Part Number: **A062C147** Part Revision: **F**
Part Name: **DIAGRAM,SCHEMATIC**
Drawing Category: **Detail** State: **Released** Sheet 2 of 5

Part Number: A062C147					3D image provided when available for visual reference only.	
	Change Notice	CN00123243	Alternates				
	Manufacturer Part (MEP)	No	Usage	Production Only			
	Release Phase Code	Production (P)	Drawing Specification	Number: A062C147_DET			
	External Regulations	No External Regulation		Revision: F			
Associated Specifications							
Number	Title	Type	Category	Sub-Category			
10903	Substances,Prohibited and Restricted	Engineering Specification	Administrative Specification	Source Control

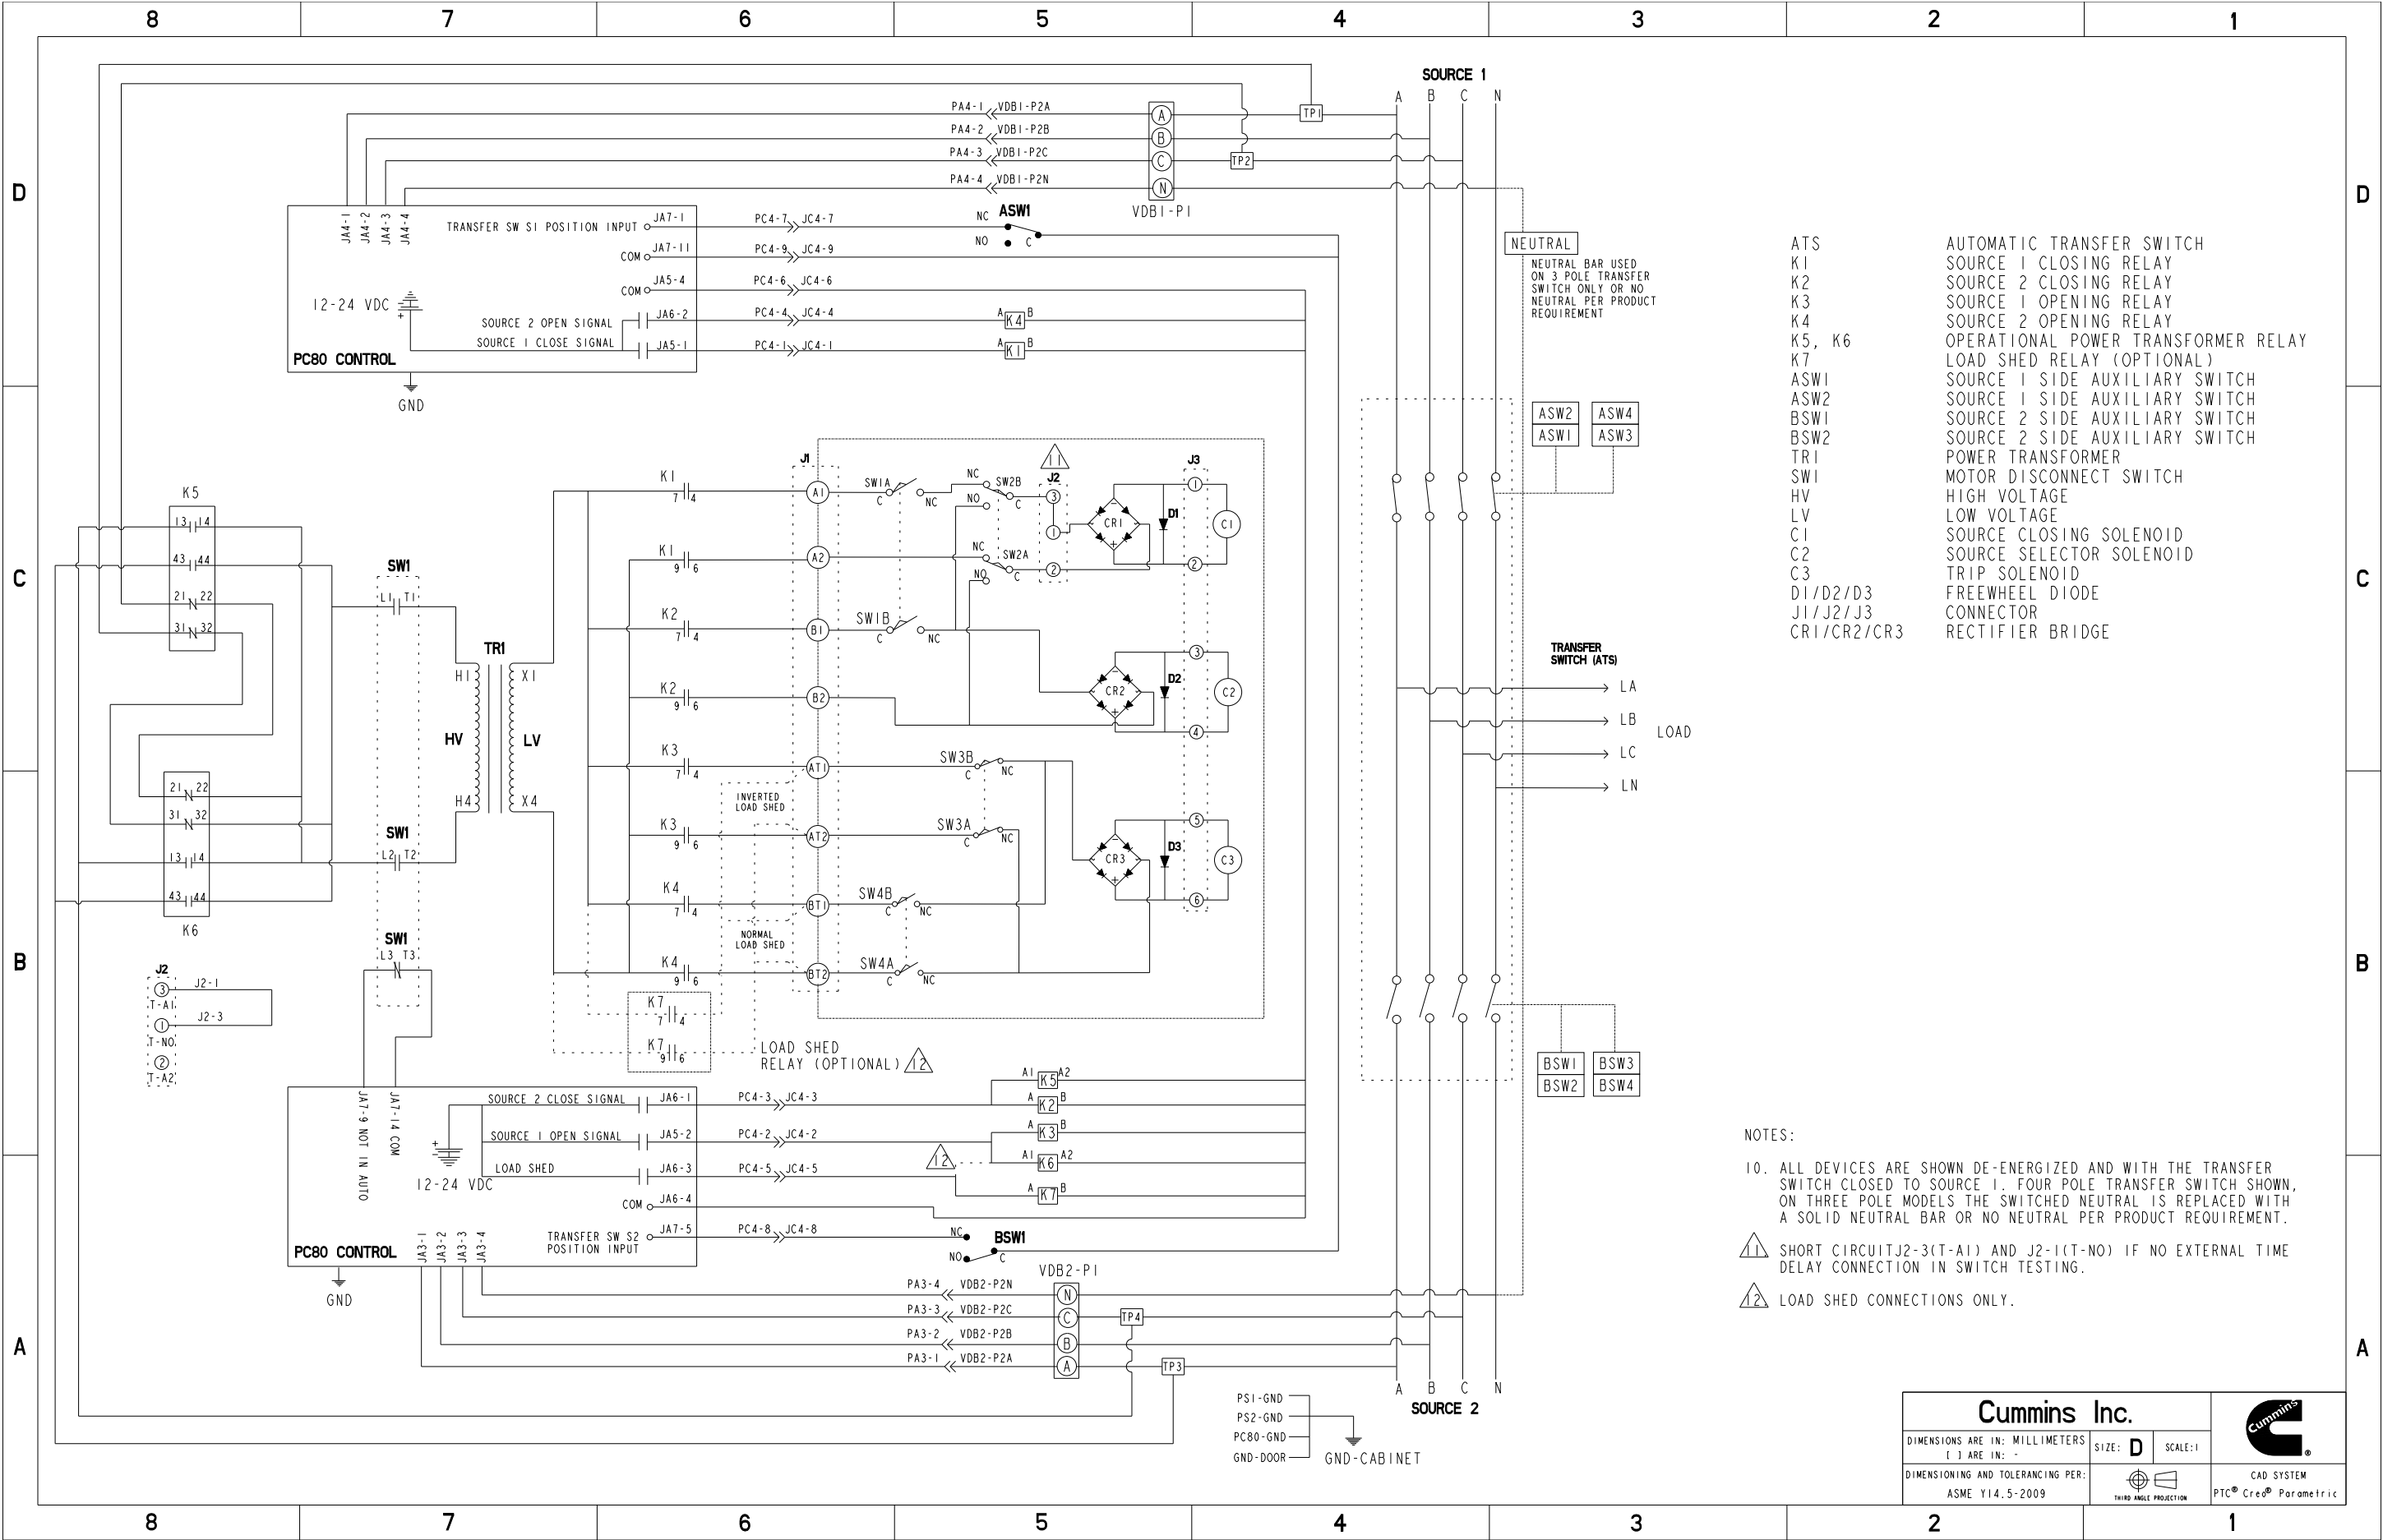
SHEET 2 1. ZONE C5: FOR SW3B CONTACT CONNECTED TO NC 2. ZONE B5: FOR SW3A CONTACT CONNECTED TO NC SHEET 3 3. ZONE D8: JA5 CONNECTION DETAILS UPDATED SHEET 4 4. ZONE A6: TEXT "PA13-20" WAS "PA13-2" 5. ZONE A6: TEXT "PA13-2" WAS "PA13-20" 6. ZONE C7: TEXT "TB1-23D" WAS "TB1-24D" 7. ZONE D6: TEXT "TB1-24D" WAS "TB1-23D" .
